Name of Proposed Subdivision Ellis Centre

Re: **Ellis Centre**  
ROK 84016

Re: Second Review of Ellis Center  
ROK 84016

FIGURE I  
 NOMOGRAPH  
 FOR TIME OF CONCENTRATION

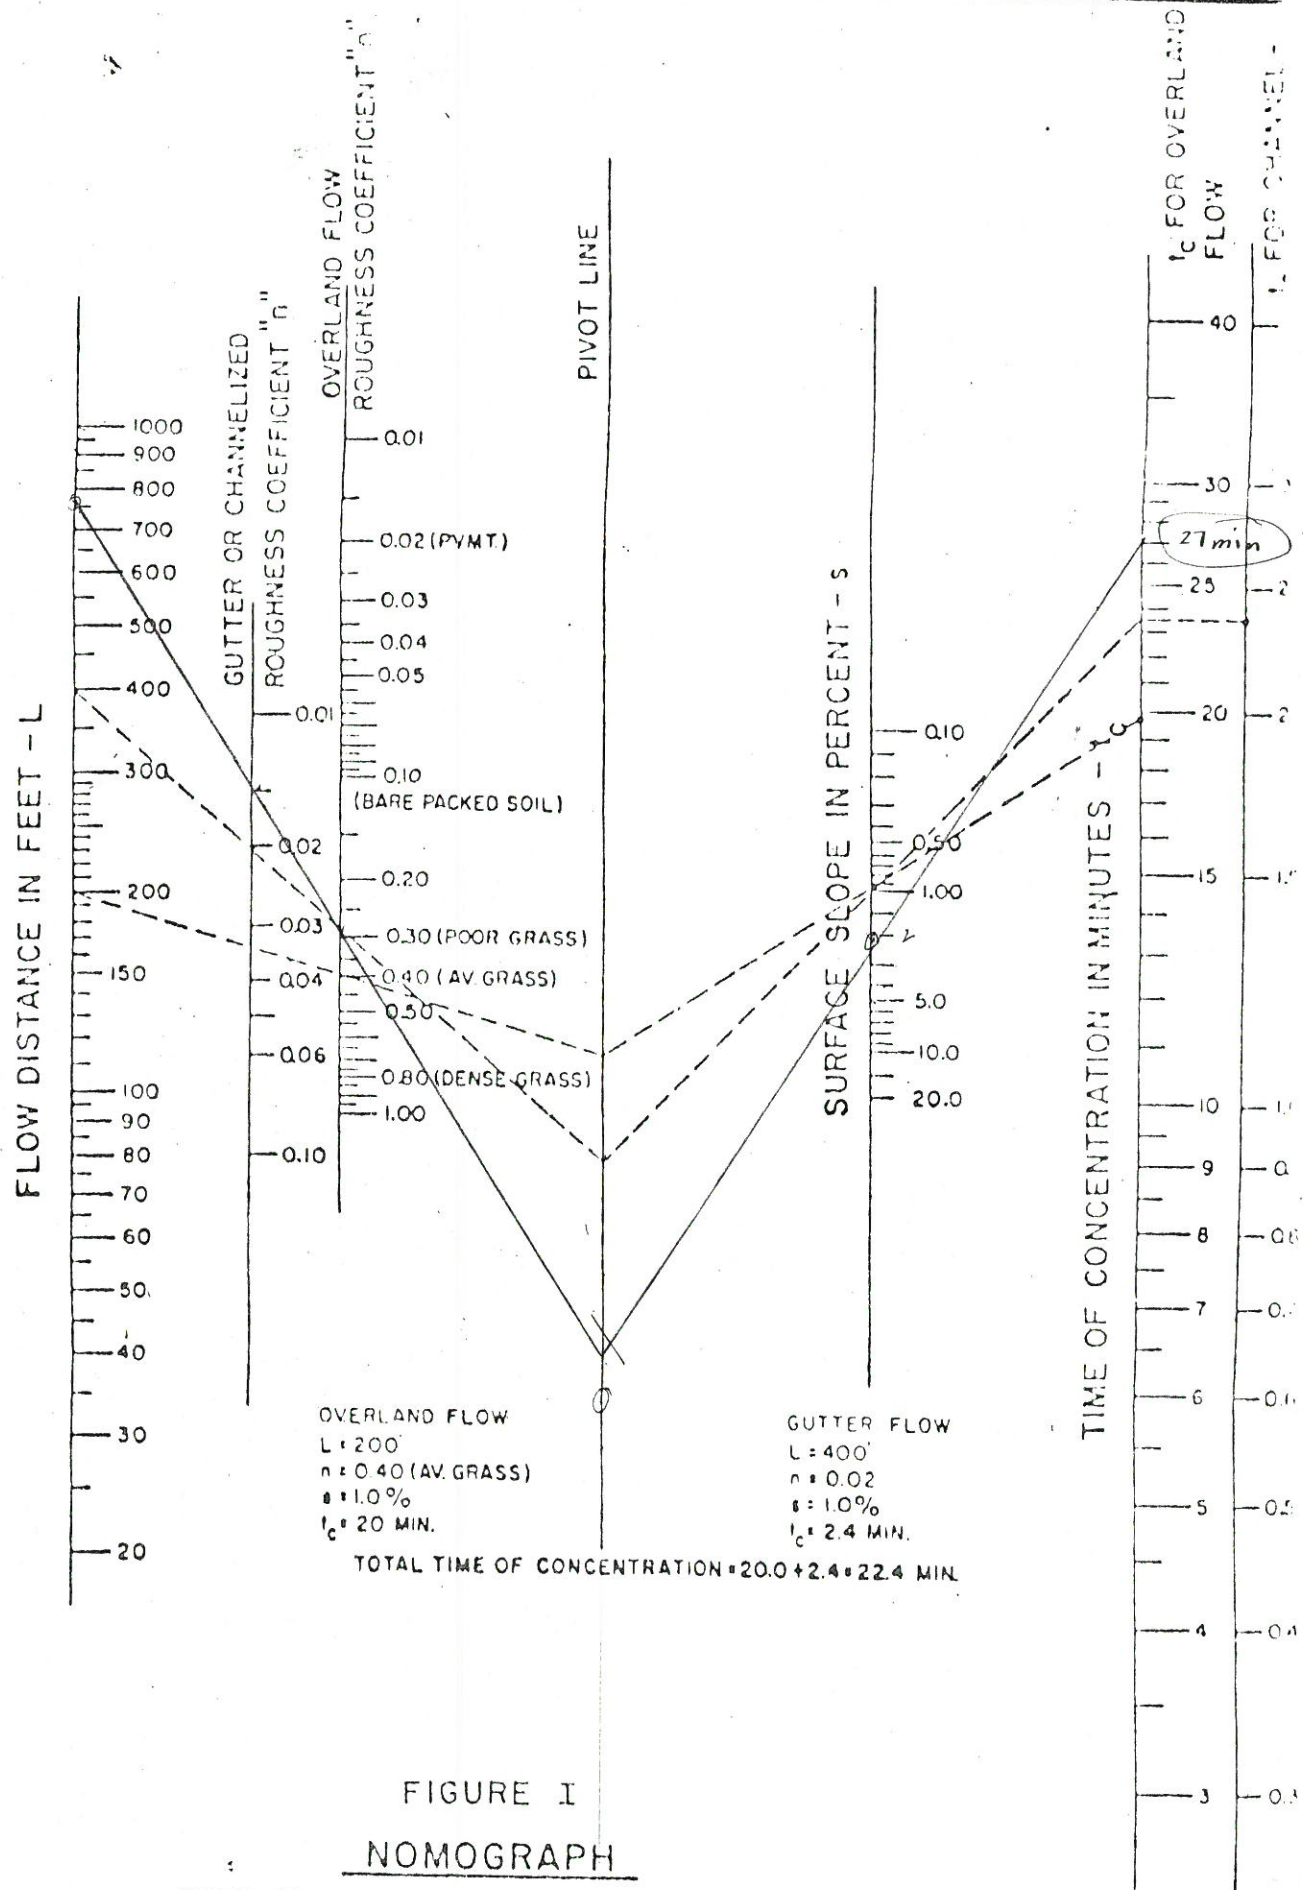
4. The Paving Plan sheet indicates the use of a C.M.P. No corrugated metal pipe may be used for drainage except in conjunction with a private driveway. Therefore the 12" drain pipe at High School Drive will need to be concrete with headwalls. No design information was furnished on the plans to show the upstream drainage area for the 12". Therefore, some question is raised as to the ability of the 12" to carry the required 25-yr storm water for the area.

5. For the sizing of street inlets and storm drains in the unnamed collector street, consideration has been given to the use of equal flow ratios for both sides of the street. If the flows in areas A-1 and A-2 are split equally and diverted to each curb gutter, then the storm water will have to cross over the crown of the street thereby flooding all lanes of traffic. The requirements of the "Standards of Design" for collector streets states that the permissible spread of water in the gutters shall be limited so that one standard lane of traffic will remain clear during the design storm. Therefore, the assumption of equal flow in both sides of the street is not compatible with the criteria to maintain the open traffic lane.

2. The easement for the drainage channel has been widened.
3. Enclosed herewith is a computer run showing the ability of the channel to carry the design storm.
4. The C.M.P. previously shown has been changed to R.C.P. and increased in size to accomodate the 25 year storm in this area.
5. The Storm Design System has been revised to provide for one dry lane on the collector street.
6. The 10 foot inlet in the sag at the cul-de-sac will pick up approximately two times the amount of run-off that will reach the inlet at design conditions.

One (1) nomograph from Standards of Design  
for calculating time of concentration.

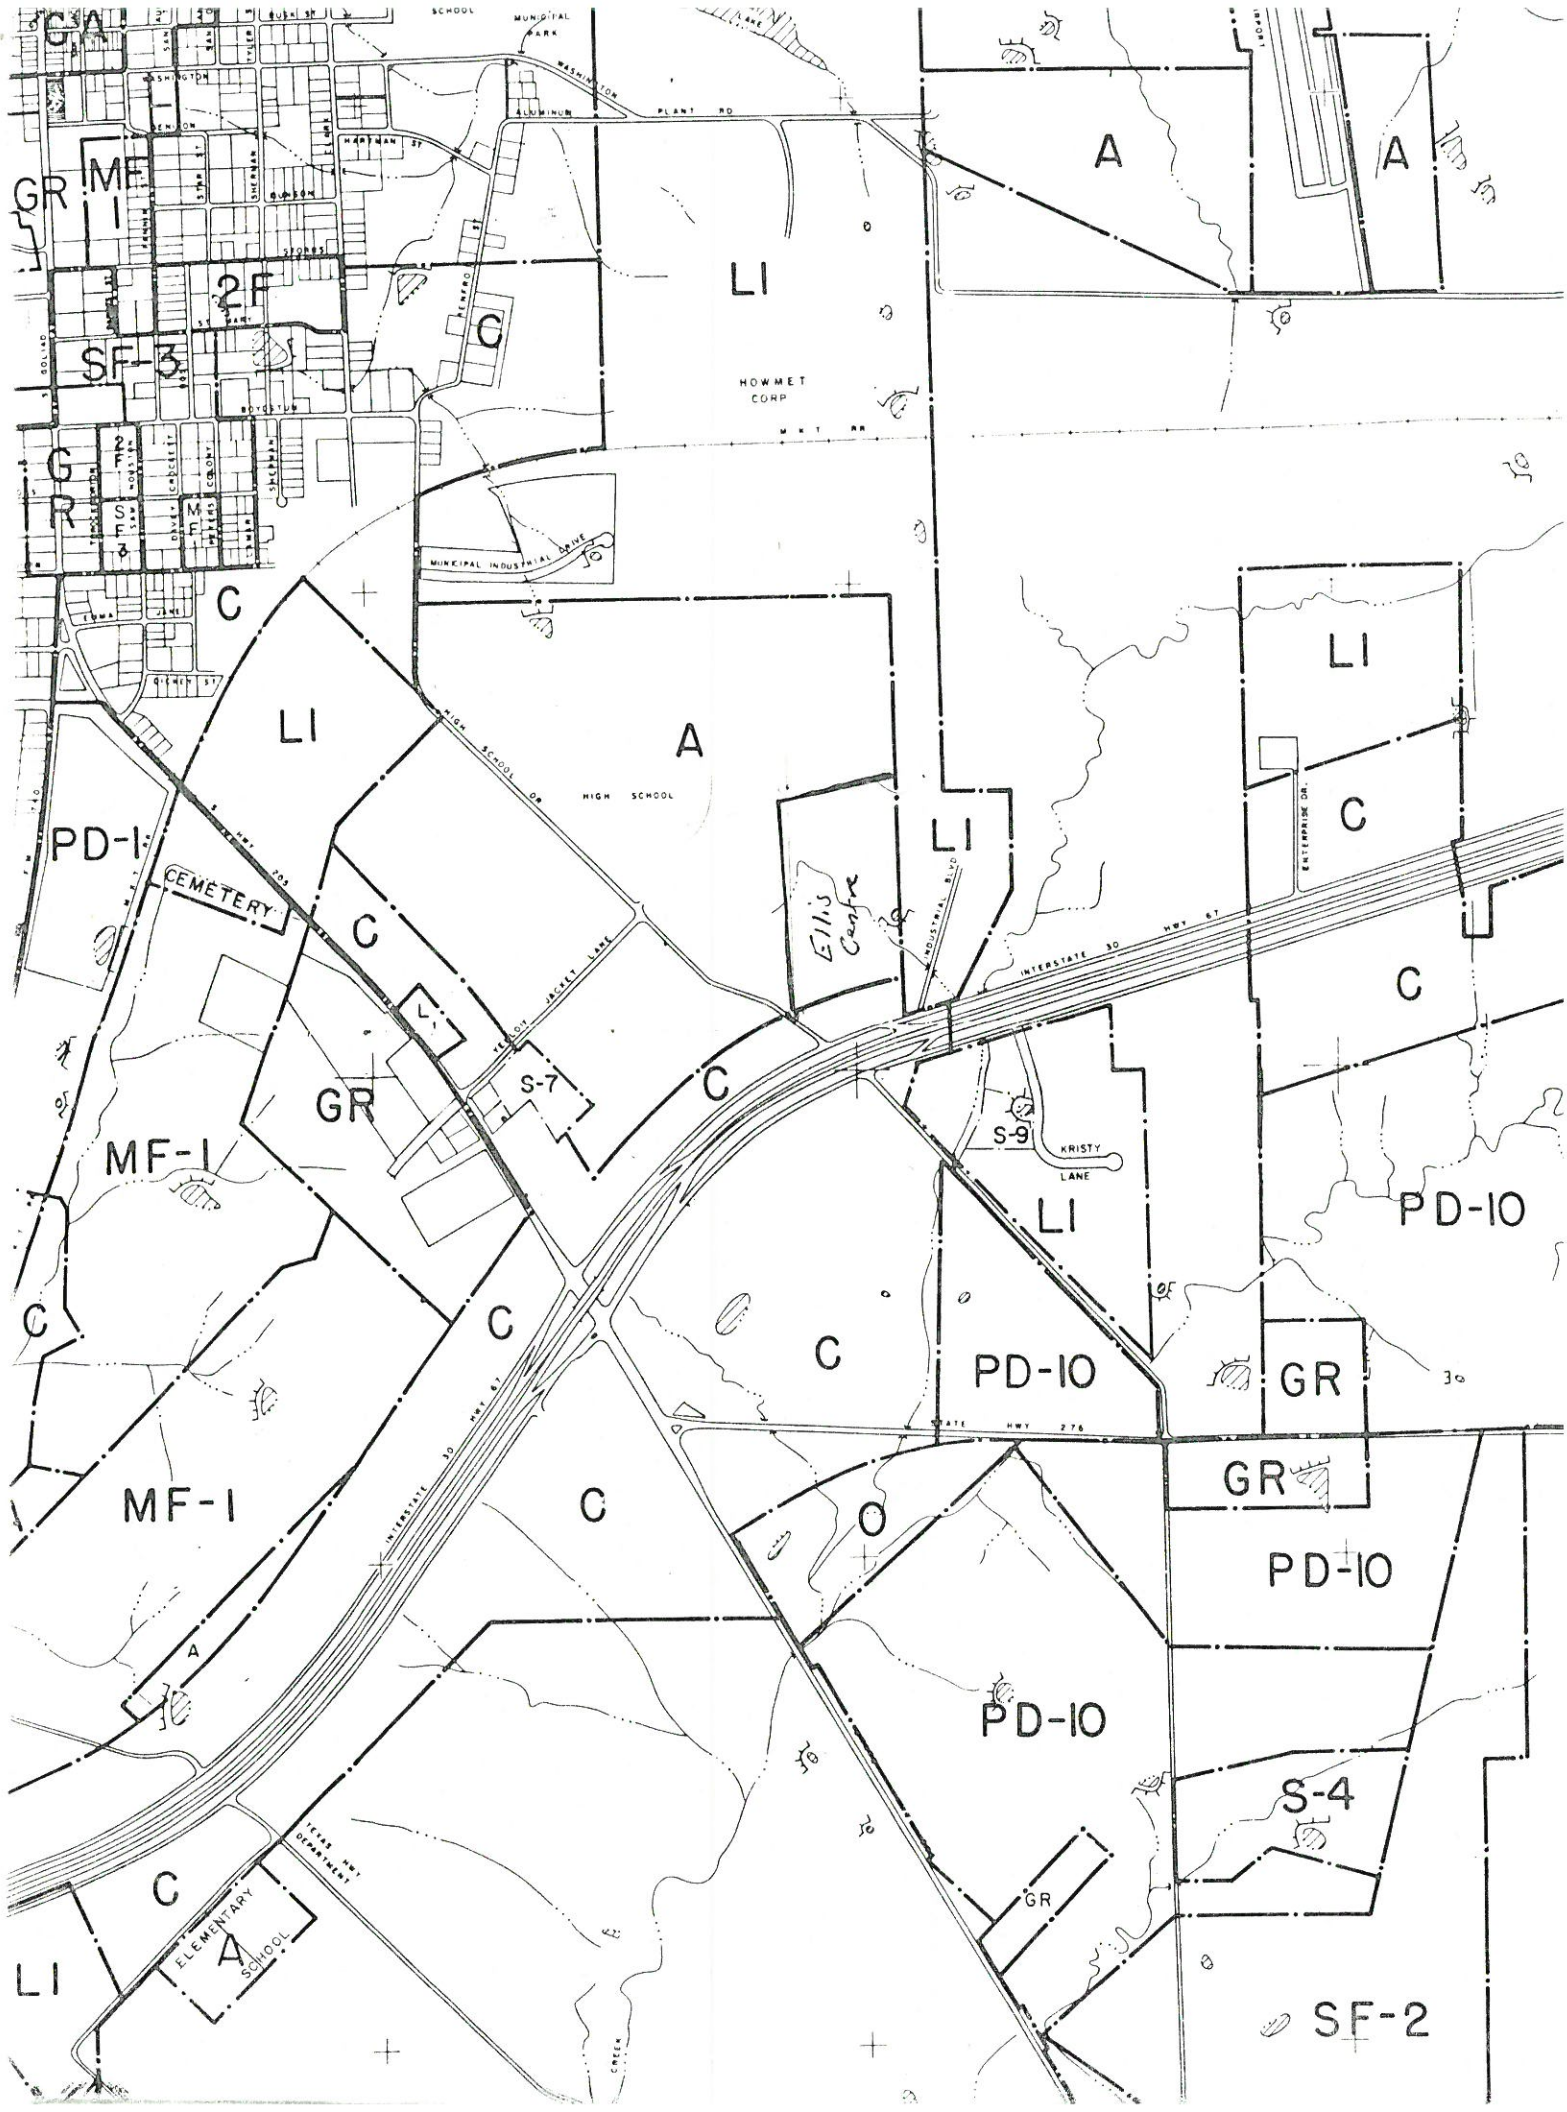
3. We have determined the open ditch as shown will convey 200 cfs rather than 240 cfs indicated on the Drainage Plan. This conveyance should be adequate, however, to convey the 25-year runoff even with the consideration of the higher "C" values for A-1 and A-2.

One (1) calculation sheet showing channel design.
